AUGUST 6, 2025

PROJECT NO: 624-6777

RE: PROLOGIS HUMBER STATION – TEMPORARY STORMWATER MANAGEMENT OUTLET

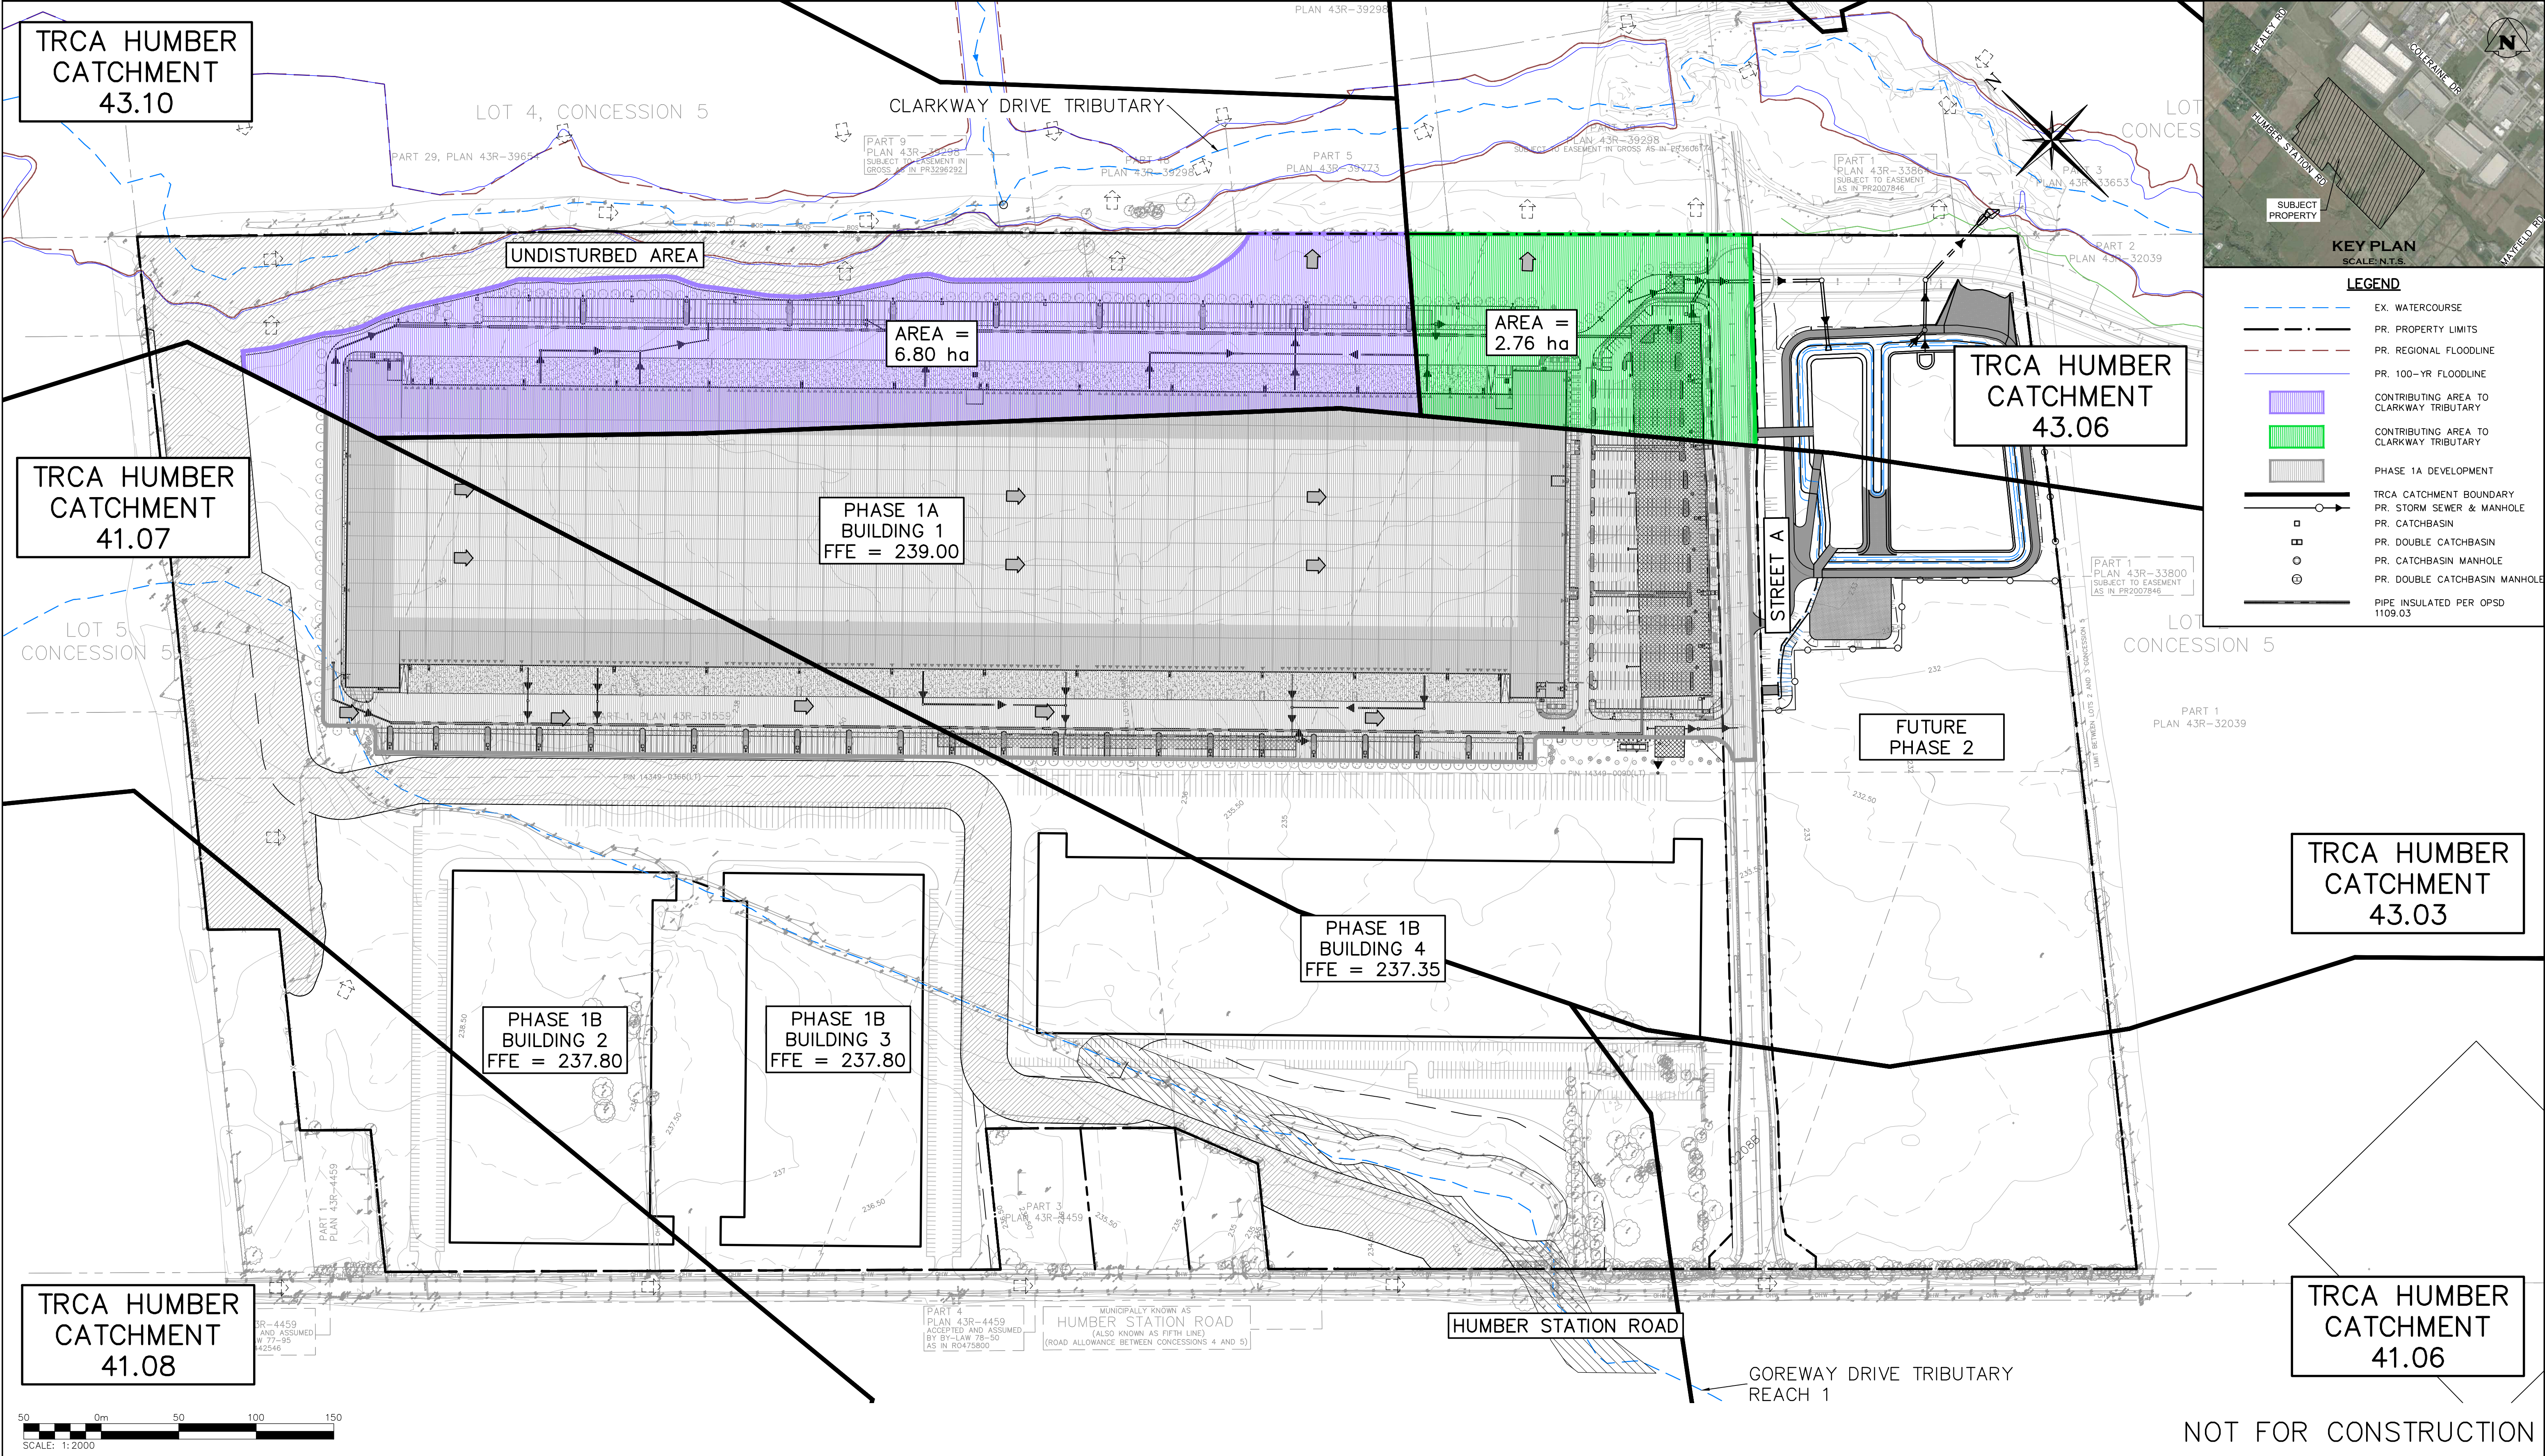
- 1. The initial step is to calculate the required site release rates for the portion of the subject properties that drains to the Clarkway Tributary under existing conditions and determine the storage requirements for the stormwater management (SWM) pond accordingly using the criterion.*

The Humber River unitary flow rates for Sub-basin 36 were used to determine the allowable release rates to the Clarkway Tributary for the property. The 9.56 ha area along the northeast property line that drains to the Clarkway Tributary in existing conditions was used for this calculation. The TRCA Humber catchments were used to delineate this area as shown in **Figure 1**.

The storage required to control Phase 1A to the unitary release rates was determined using VO and the TRCA 12-hour AES storm events since they produced the highest peak flows and storage values out of the TRCA storm events recommended for the Humber River watershed. The 100-year release rate was calculated to be 0.236 m³/s. To control Phase 1A to this release rate, a storage of 18,343 m³ is required for the 100-year event and a storage of 45,688 m³ is required for the Regional event. Refer to **Figure 2** for the post-development drainage area plan and **Table 1** below for calculated release rates and required storage. Detailed model parameters are provided as an attachment to this letter, as is a copy of the VO model.

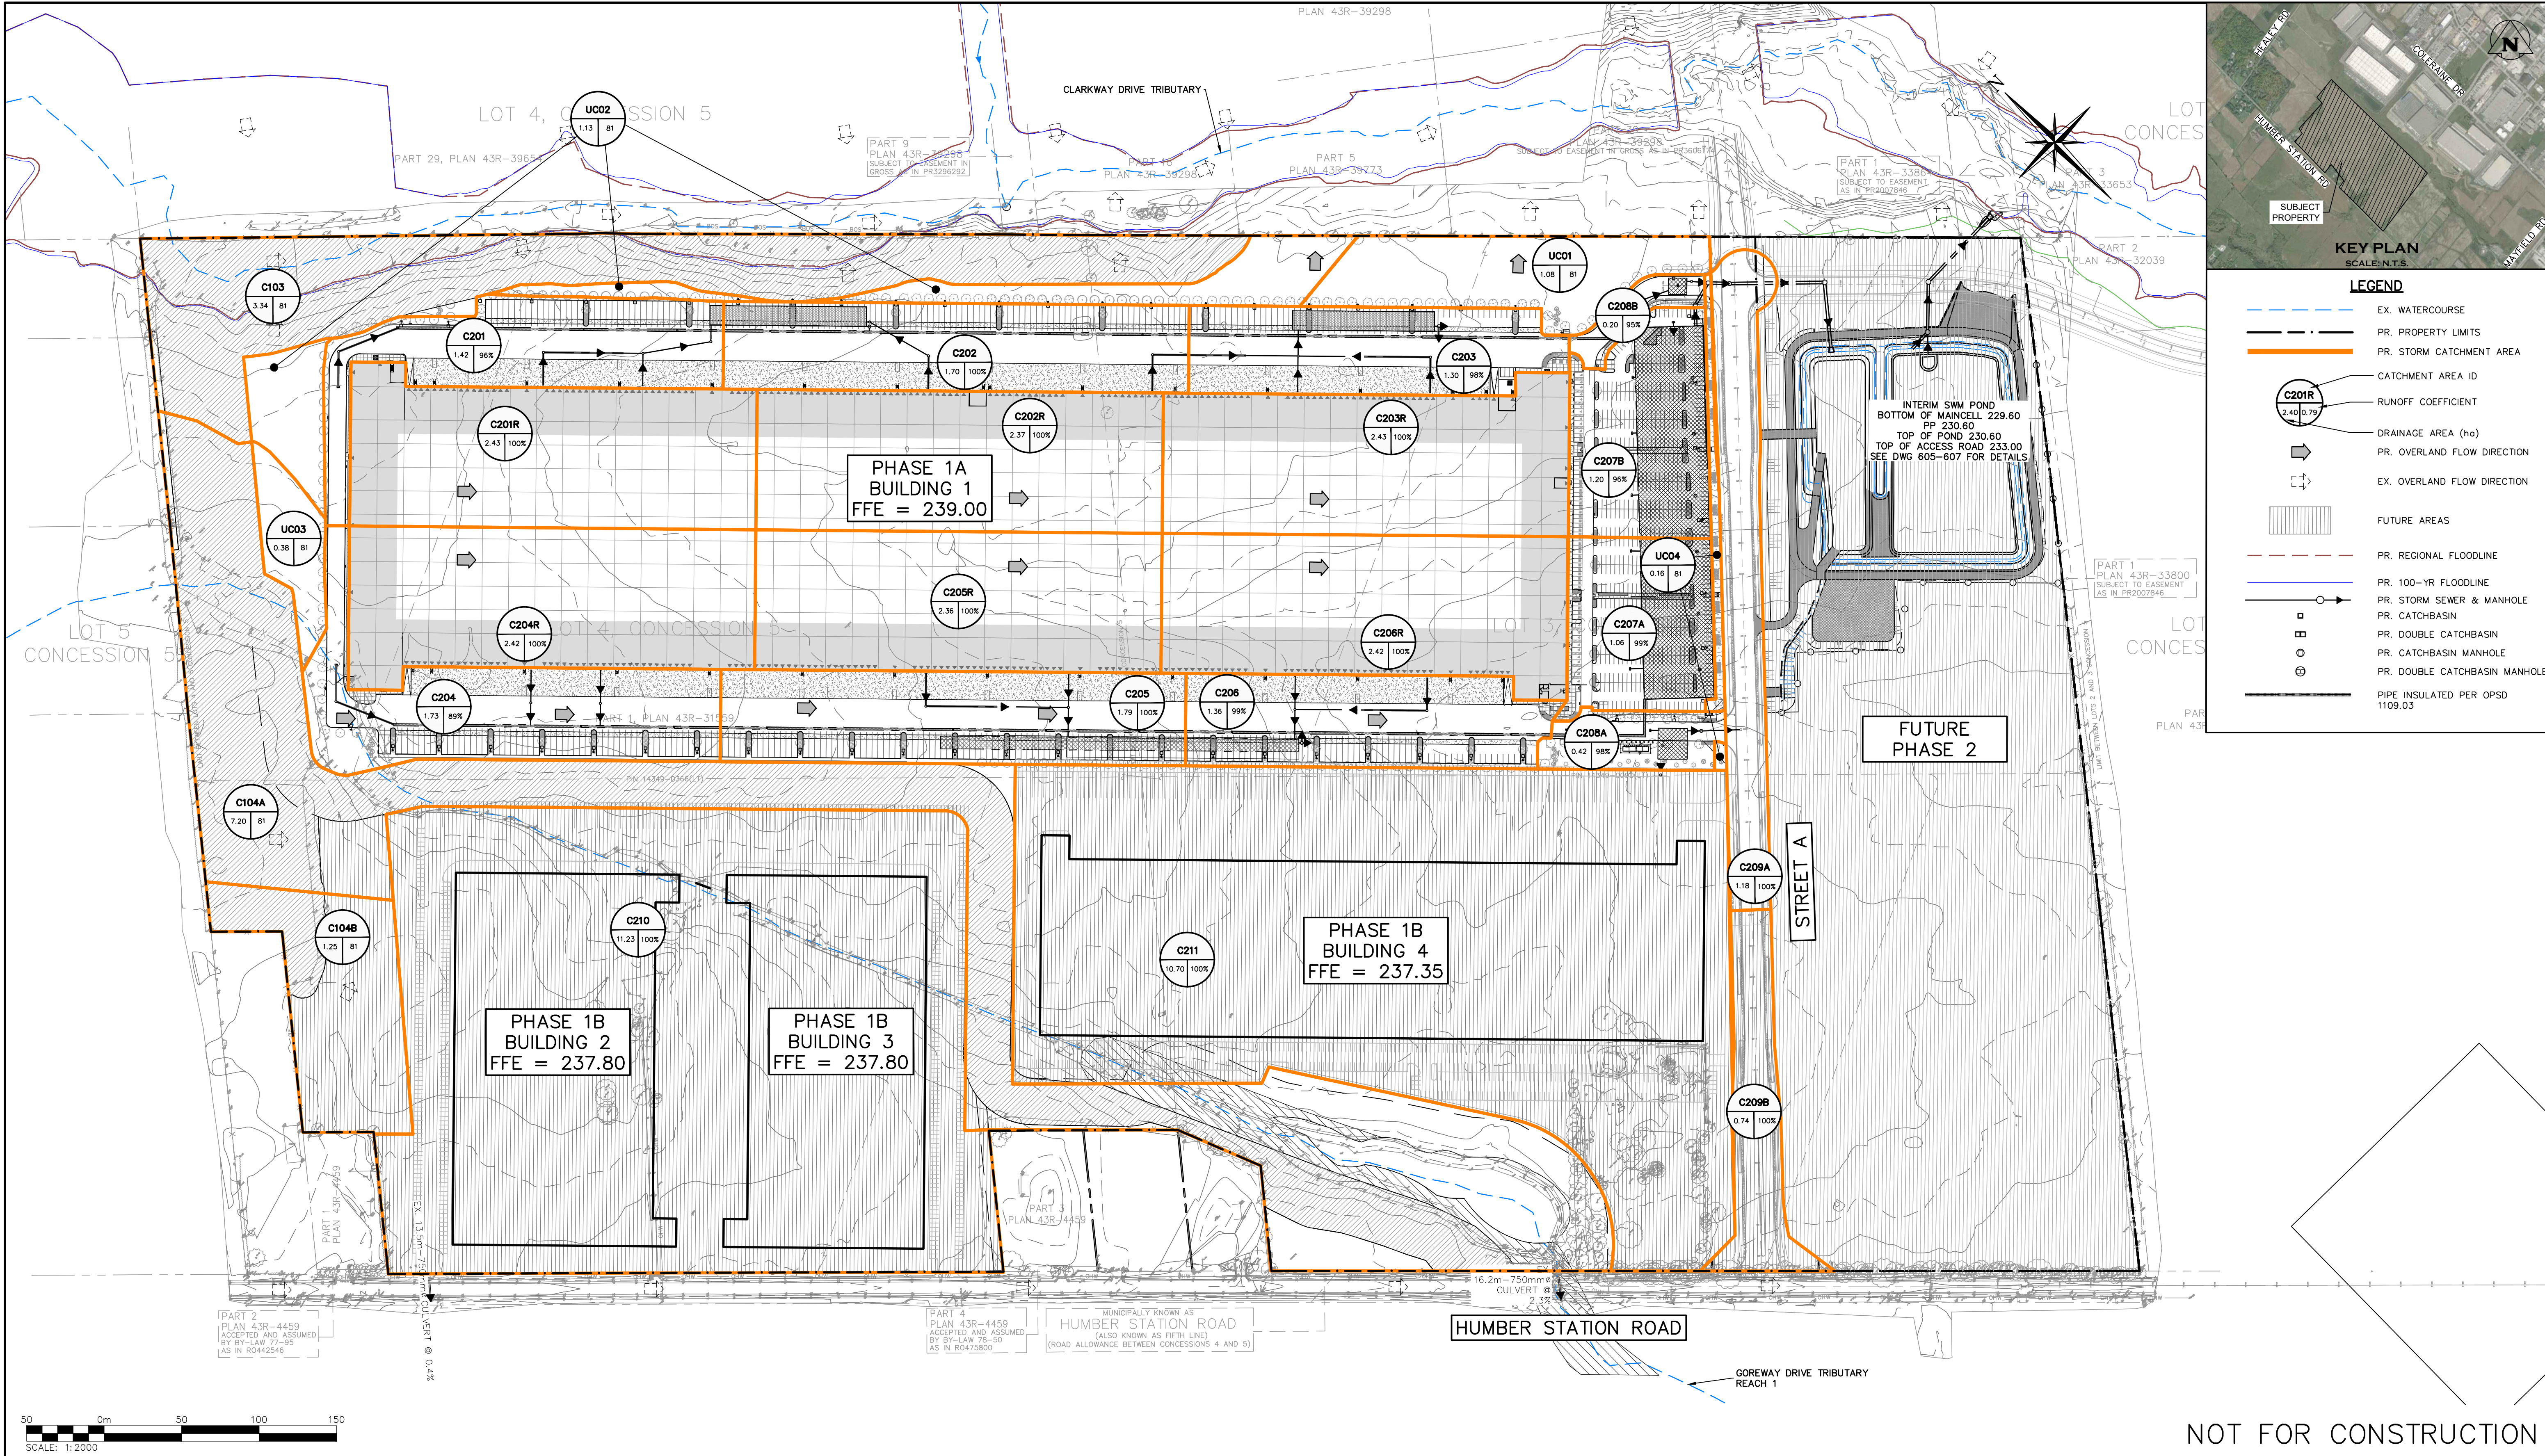
3. *Identify contributing drainage area to the proposed interim outlet location in Clarkway Tributary and summarize in a drainage map.*
 - a. *Compare the upstream area and diversion area.*

Figure 2 attached shows the post-development catchment areas from Phase 1A that are to drain to the interim outlet location as well as the proposed SWM facility. **Figure 3** shows the upstream area contributing to the tributary and highlights the areas within Phase 1A that are proposed to be diverted. The diverted area is summarized in the table below. As
